USNRC APPLICATION
SUA-1341 License Amendment
Ludeman Project
Converse County, WY

June 2013

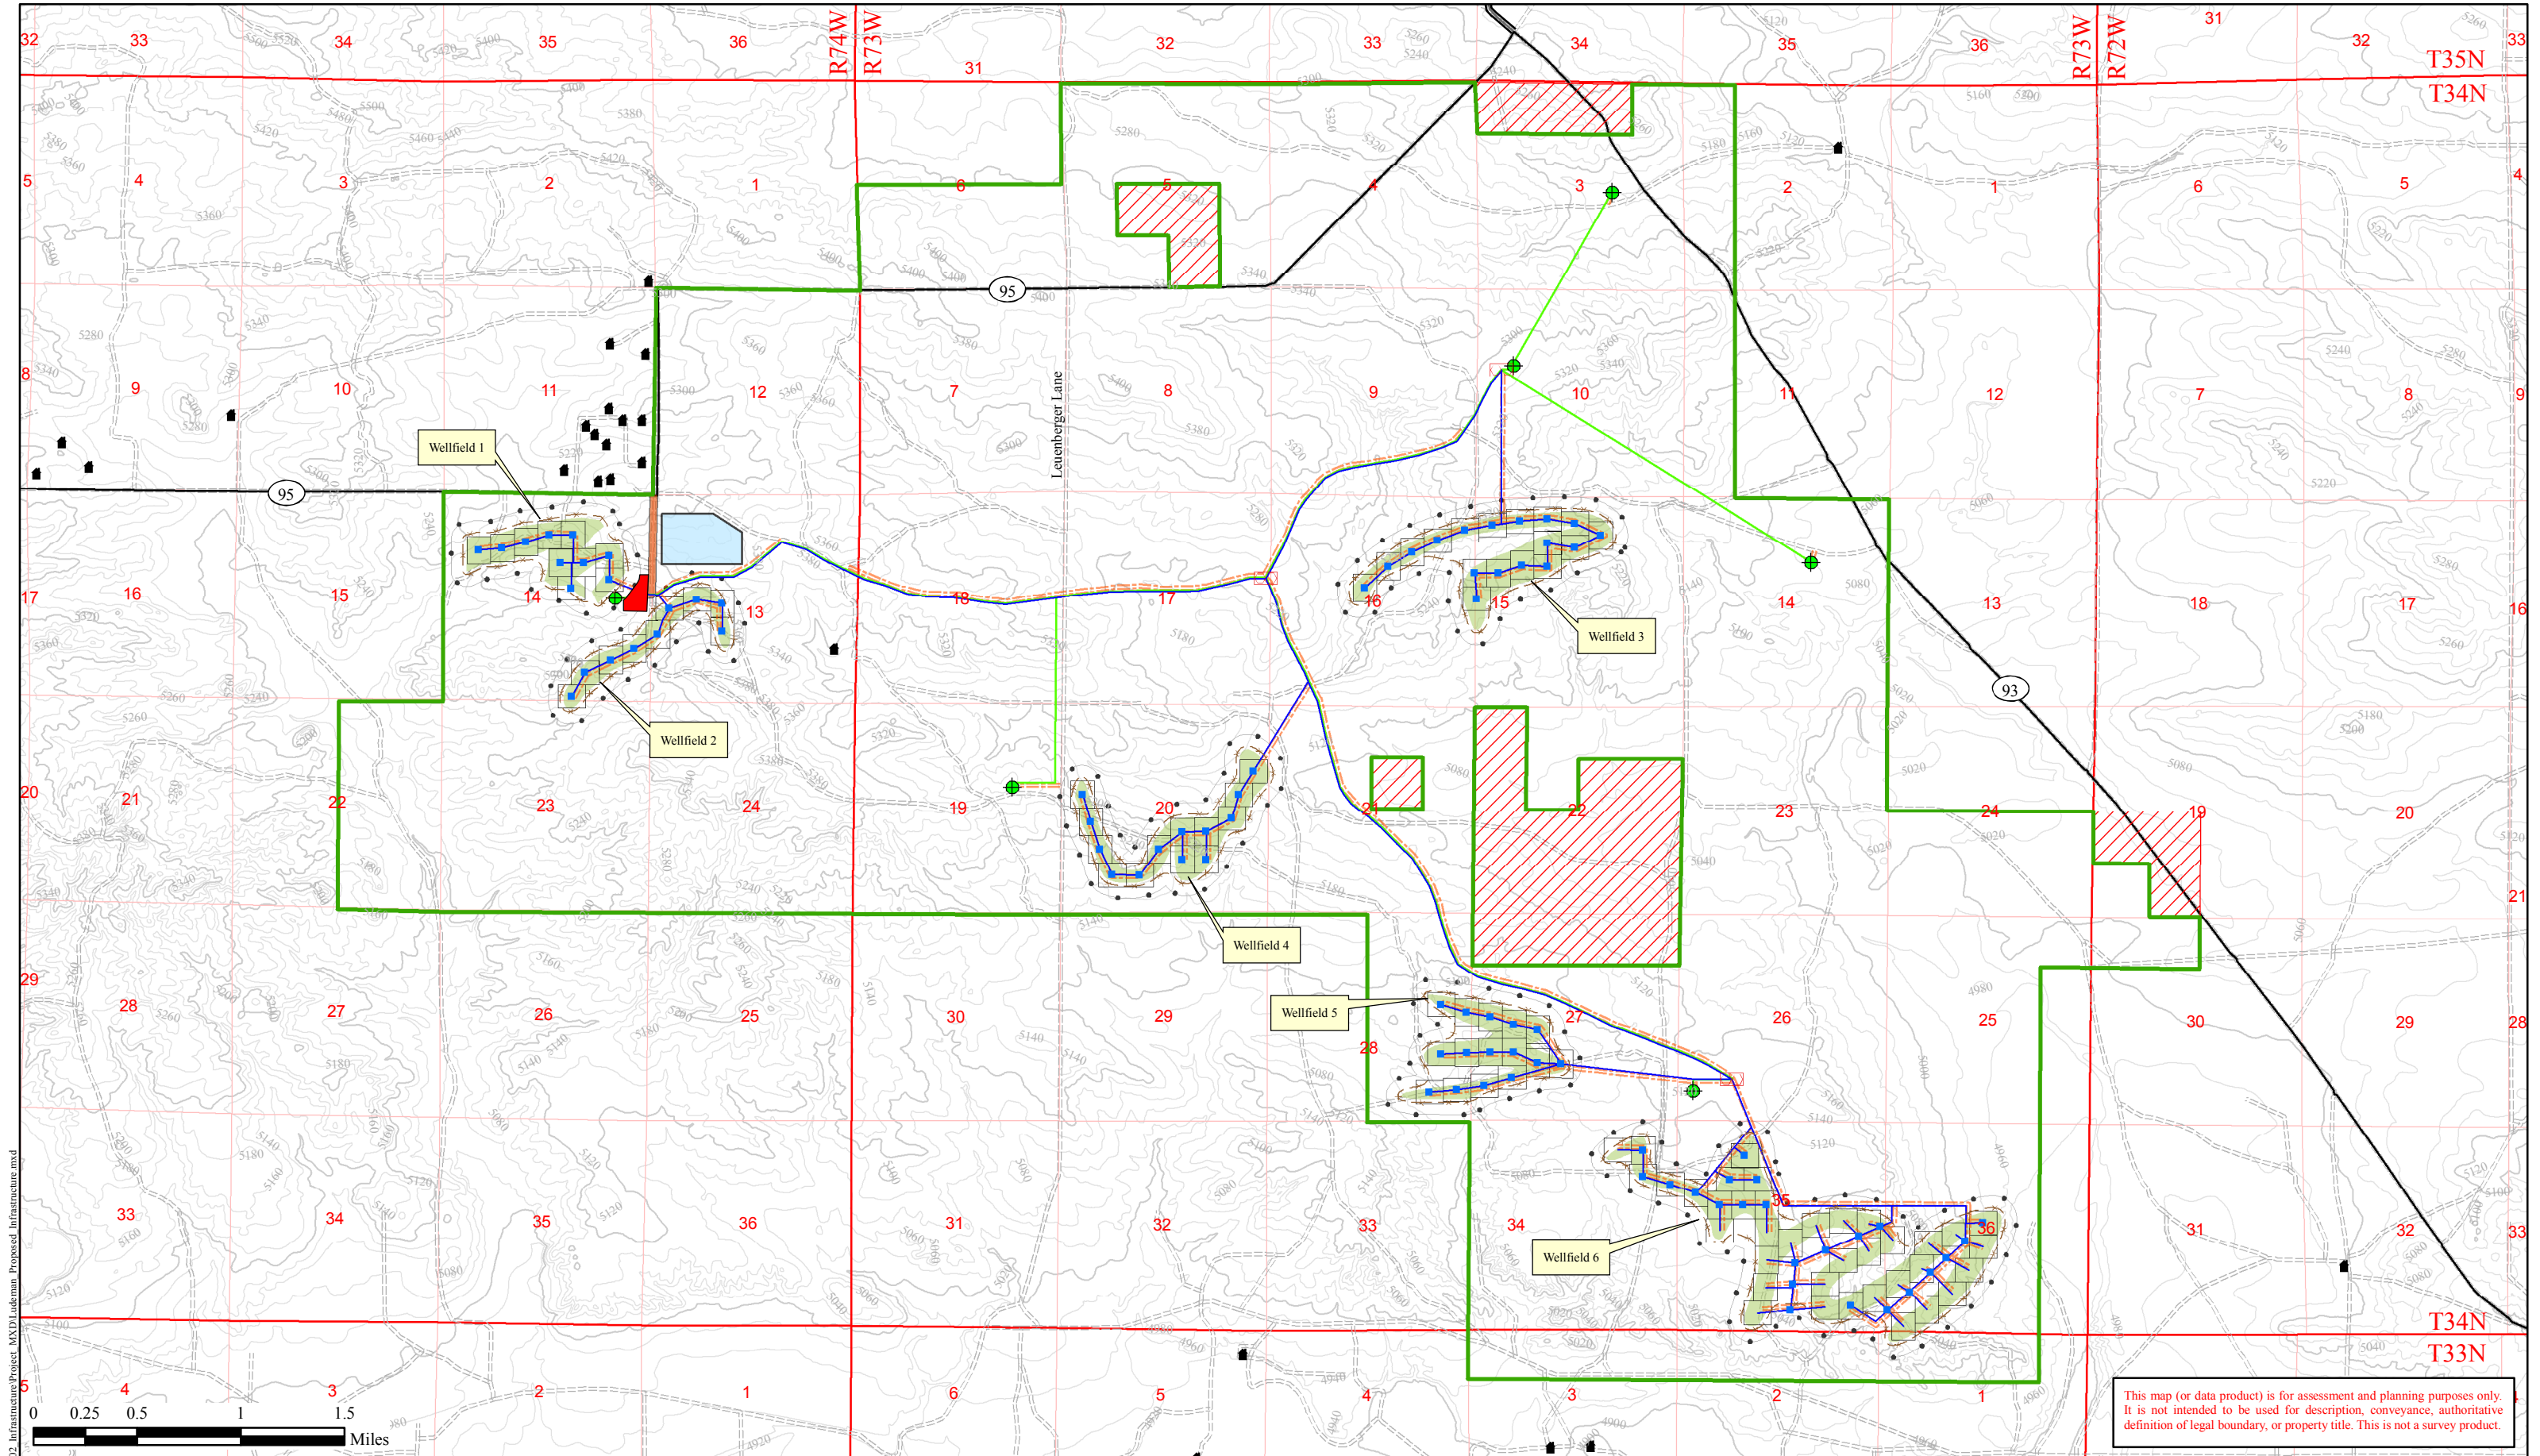
Please provide plan views of each of the proposed Satellite areas which show the baseline conditions and features for each phase of the Ludeman Project.

A. Please provide a current, baseline plan view of each of the proposed Satellite, showing each of the physical (i.e., man-made) attributes listed below:

B. Please provide a plan view of the Project areas with the same scale and size as the baseline plan view requested above and indicate each of the physical (i.e., man-made) attributes listed above for each phase (i.e., construction, operation, aquifer restoration, and decommissioning) of each of the proposed Satellite areas. Please provide these plan-view figures in an electronic format with similar features to Figure 2.1-2 in the ER, including enlargement of the Satellite areas to allow the details to be discernible. The views of the existing, current Ludeman site will serve as a baseline view and the other phased views will assist in the NRC's description of the Proposed Action and the Alternatives in Section 2 of the EA and in its evaluation of the impacts of the Ludeman Project for each phase. Specifically, comparable figures of each Satellite area are necessary to evaluate the impacts of the NRC's Alternative 3 and to compare impacts among the three Alternatives chosen by the NRC for further analysis (i.e., Alternative 1: Proposed

The existing TR Figure 3-1 will be updated to depict the proposed project's conceptual infrastructure and other foreseen structures related to the Proposed Action. NRC's request for Uranium One to provide a plan view for all physical attributes for all phases of the project is not required under NUREG 1569 or 1748. Furthermore, this request was not required in previous Uranium One and/or other license applications that were deemed technical comprehensive and currently licensed. Uranium One believes TR Figure 2.2-2 and Figure 3-1 are adequate to assess the nature and extent of present and proposed operations for the proposed Ludeman Project. The revised infrastructure is shown below.

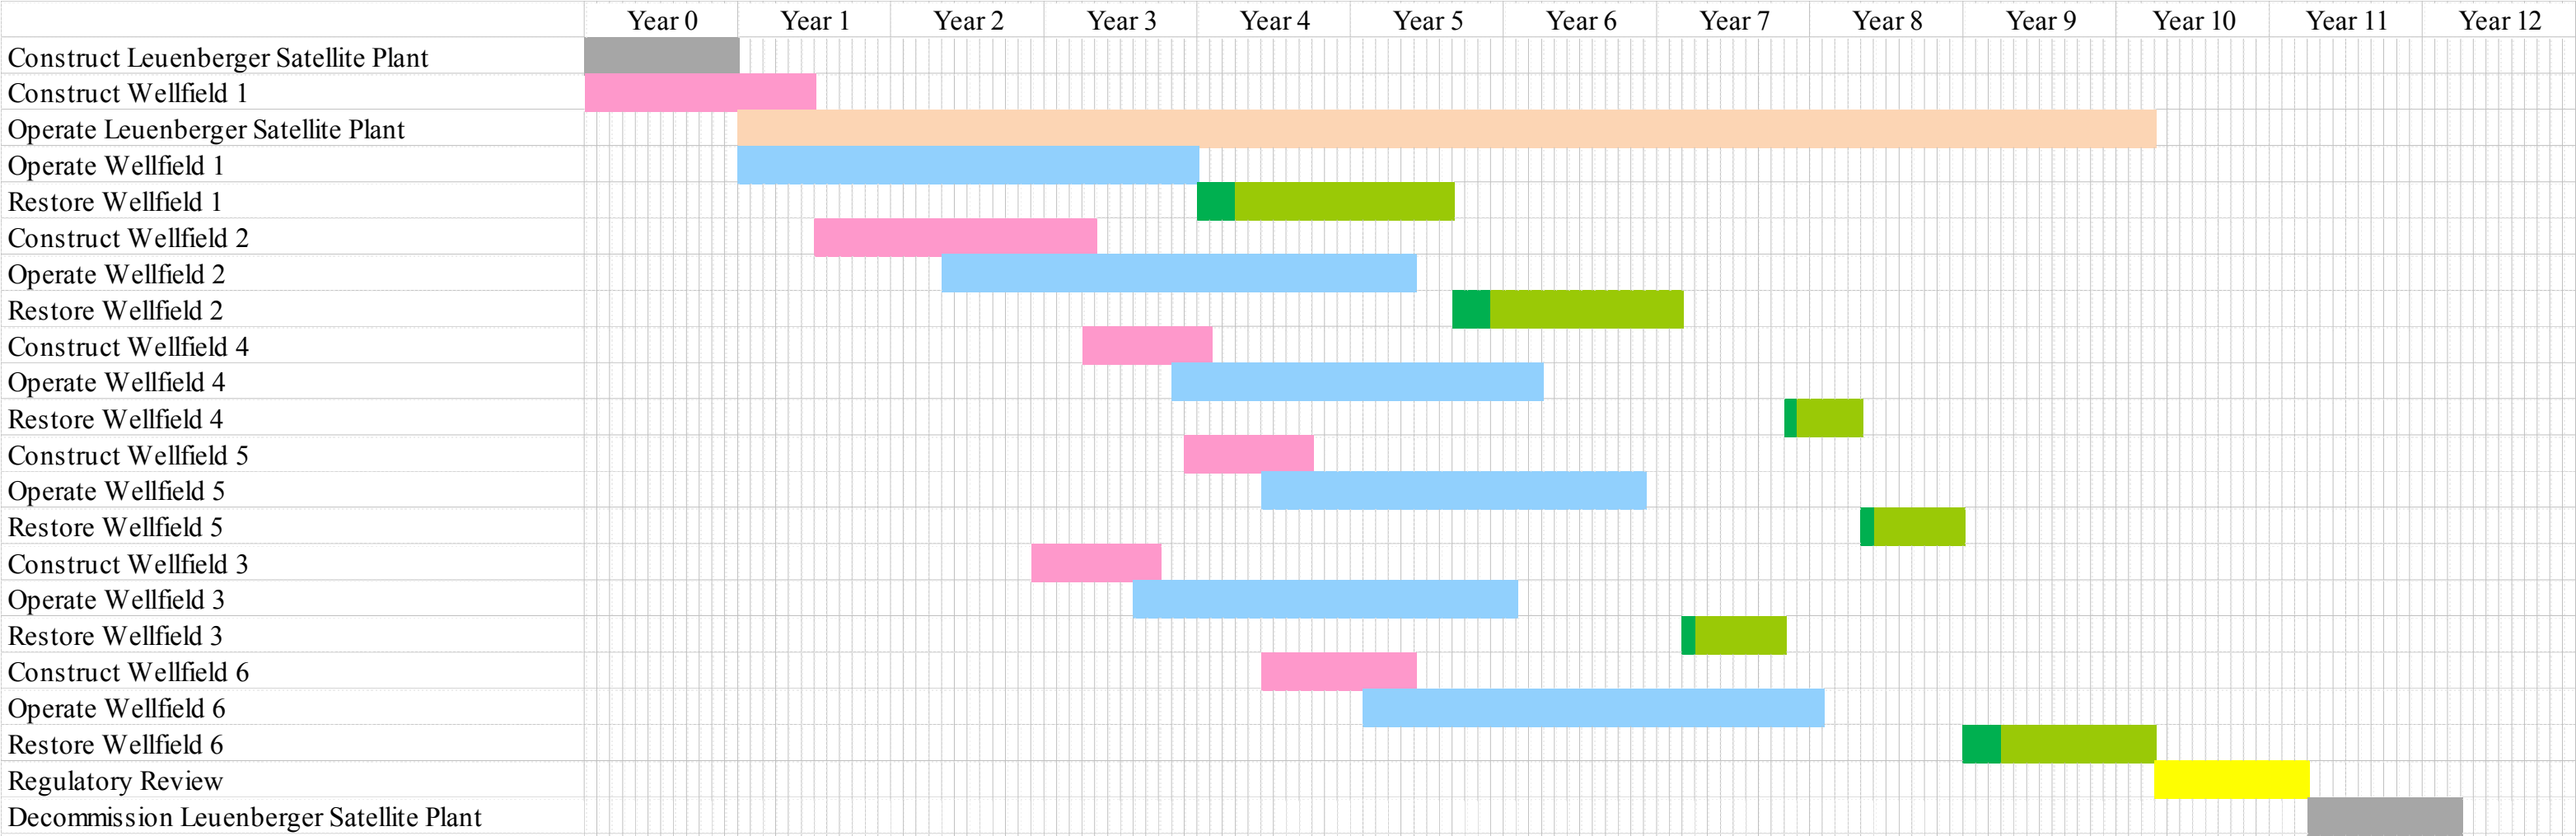
Please note any changes to the order of development of the Satellite areas that is shown in Figure 1-4 of the TR.

As a function of economics of the current and projected status of the uranium industry, Uranium One evaluated the current Ludeman Project application to assess if certain operational components of the proposed plan could be optimized. First and foremost, this evaluation identified the utilization of a single satellite plant as opposed to the three satellites proposed in the original application. A single satellite plant has been deemed more economically feasible and would diminish a number of potential impacts. It is Uranium One's strong opinion this modification will improve the viability of the project and overall reduce any potential impacts.

A revised schedule illustrating the construction, production, restoration and decommissioning phases of the proposed project will replace the original schedule in all applicable sections of the application. The revised conceptual schedule is shown on the following page.
